Re: 3333 East River Road Service Station and Convenience Store Amended Special Use Permit
Approval Application
White Arrow Service Stations, Inc.

On behalf of my client, White Arrow Service Stations, Inc., I am pleased to submit the attached site plan for the amended special use permit for the proposed service station and convenience store at 3333 East River Road.

SITE PLAN AND DETAILS

L-1.1

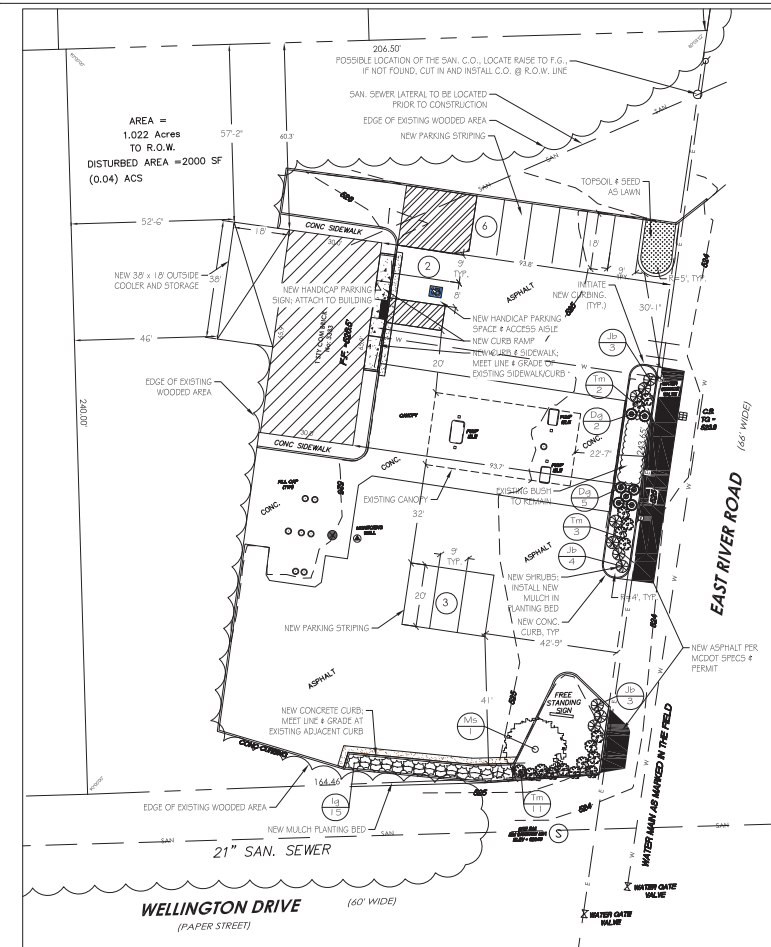
There is no change in the proposed convenience store from earlier, however, we are additionally requesting approval of an addition, 18' x 38', which will be added to the rear of the store. The addition is needed for an exterior cooler and storage of goods, equipment, and used cans and bottles, etc.. The project previously received Special Use Permit from the Town Board, however, the owner now feels the addition not then requested will be needed to make the project successful. Without the addition, area within the existing building will need to be put to cooler and storage use which will take out a large portion of otherwise usable retail space jeopardizing the success of the project.

The addition is to be entirely on the rear of the building and the woods now surrounding the building will remain to essentially block all views of it from neighboring parcels. The addition is intended to be of vinyl siding with color and style matching the wood veneer facade on the front of the building.

No.	DATE	DESCRIPTION
1	05/16/20	
2	01/21/21	ADD OUTSIDE COOLER
